Sinai Water Resources Study.
Arish-Rafah Groundwater Management Study
Supplementary Report on Recommendations
for Further Investigations (Phase B)

Institute of Hydrology
February 1989
5/27D1

EEC Project SEM/01/220/022

Figure 2.1

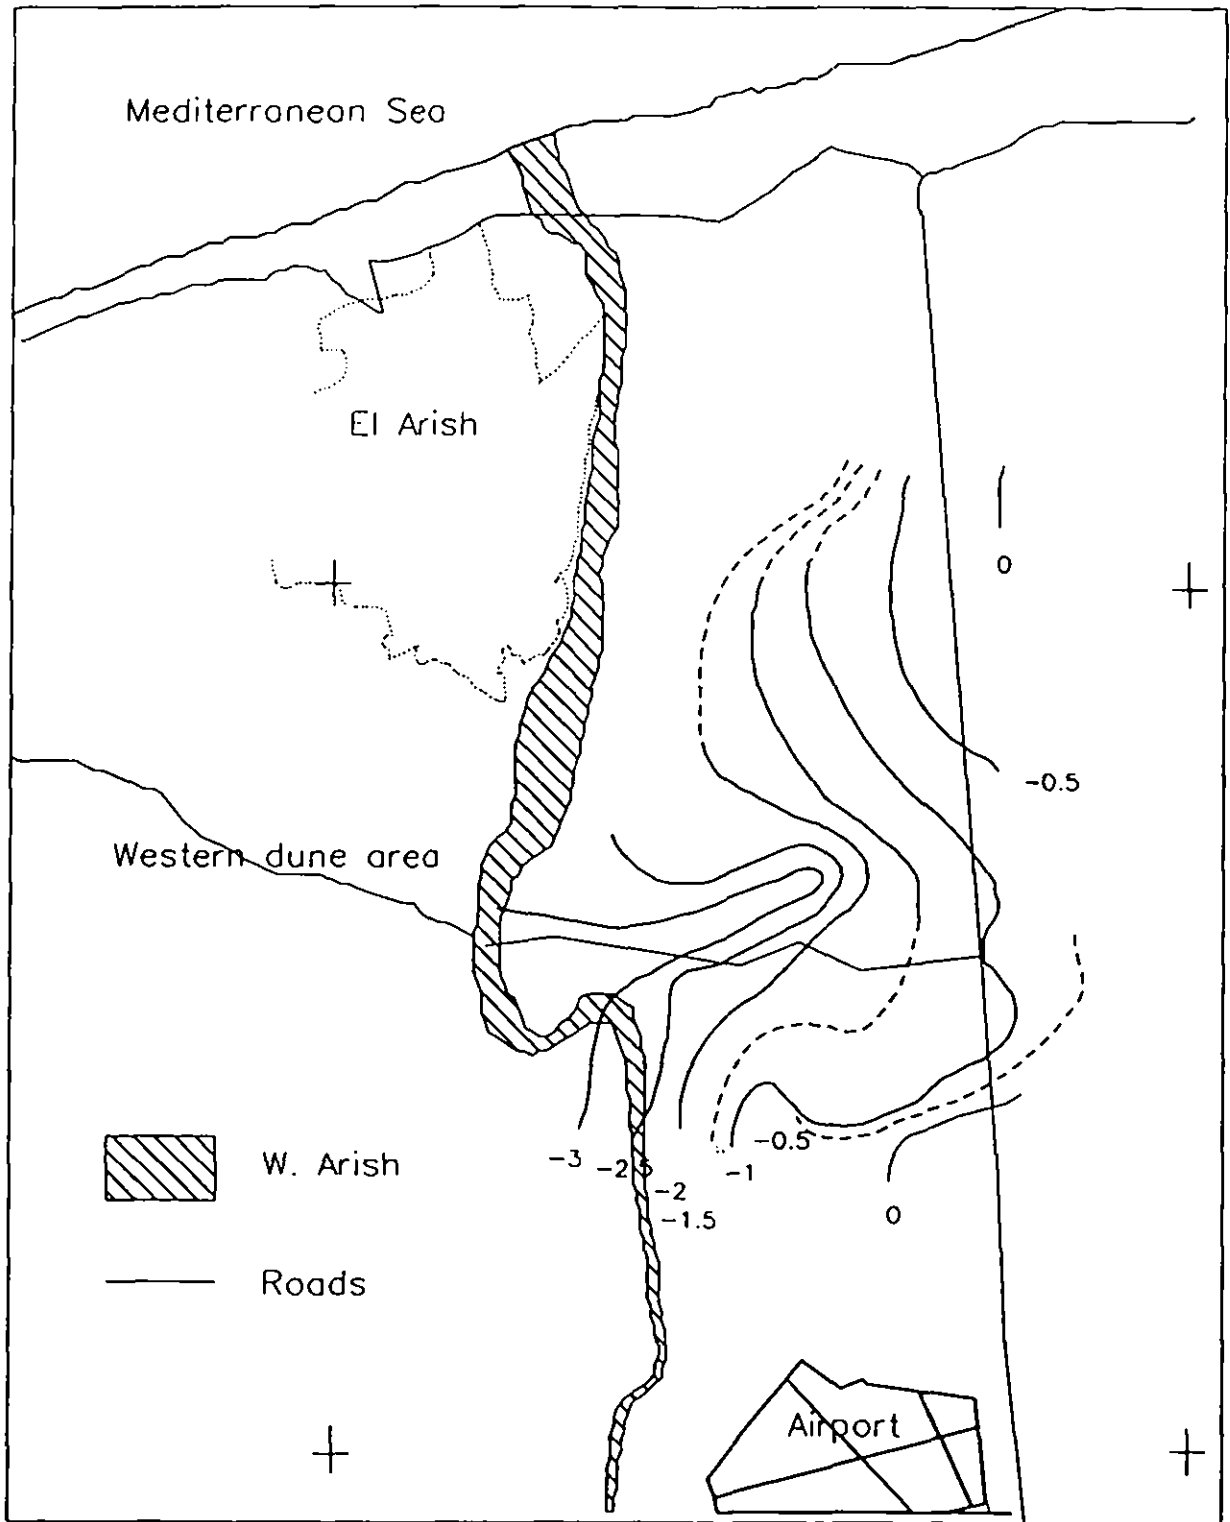
The aquifer area has not been fully defined, but assuming this to be about 28 km² (within the zero contour), a storativity of 10% and an average decline in water level of 1.5m since 1981 (Figure 2.1) then the depletion in storage between 1981 and 1988 was 4.2 Mm³ or 0.6 Mm³/y (1644 m³/d), assuming no recharge.

The change in salinity between 1981 and 1988 is shown in Figure 2.2, where positive values indicate an increase in salinity. This would generally suggest that water quality has deteriorated in the northern part of the central area. This is more likely to be due to saline intrusion, the greatest increase being along the wadi channel just east of Arish. Aside from a few local areas, the water quality over a large part of the central area has actually improved or has not shown any significant change since 1981 despite the decline in water level (Figure 2.1).

Figure 2.2

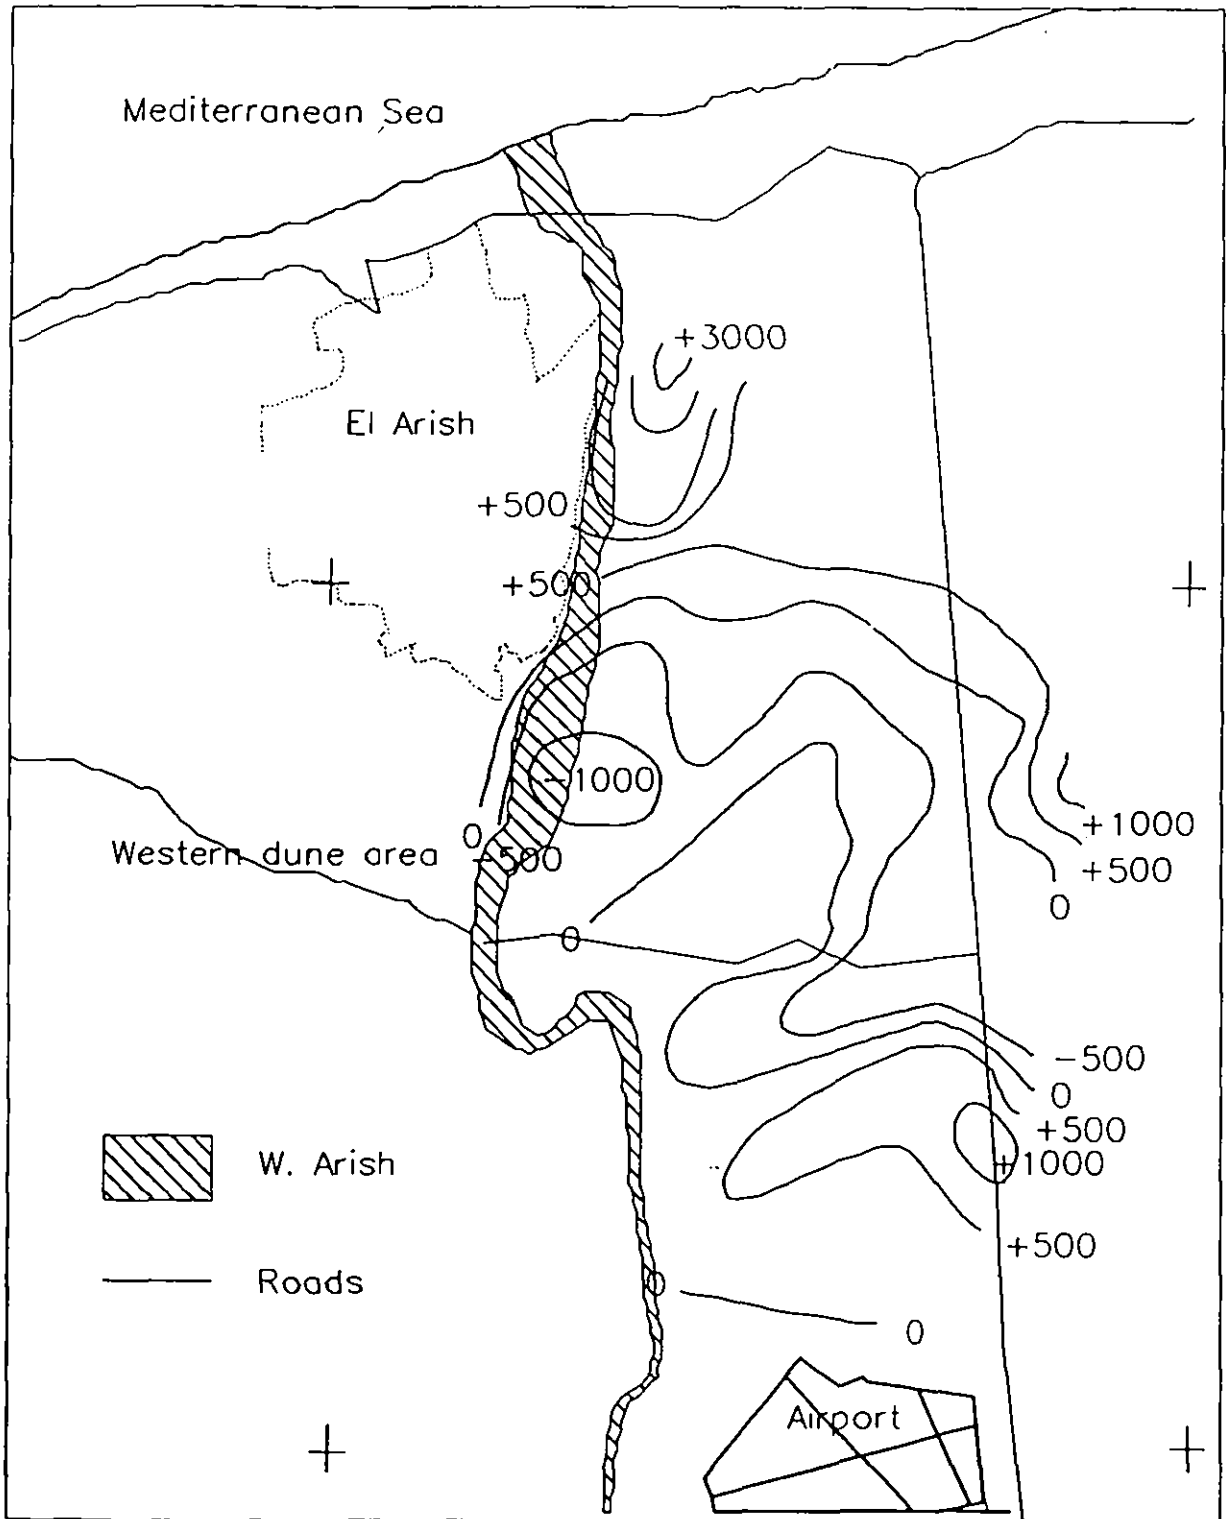
These results indicate that abstraction in the central area is causing a decline in heads which has resulted in inflow from the surrounding area and hence the water quality change will be related to the different water quality in the surrounding areas. Thus those sites in the north would be affected by saline intrusion, those to the east by poorer water in the eastern dune areas (with slightly better quality water along the Wadi Mazar), those in the south by good quality water entering as inflow along the alluvium of the Wadi Arish, and those in the west by reasonable quality water entering from the western dune area. Detailed hydrochemical studies should be able to identify the
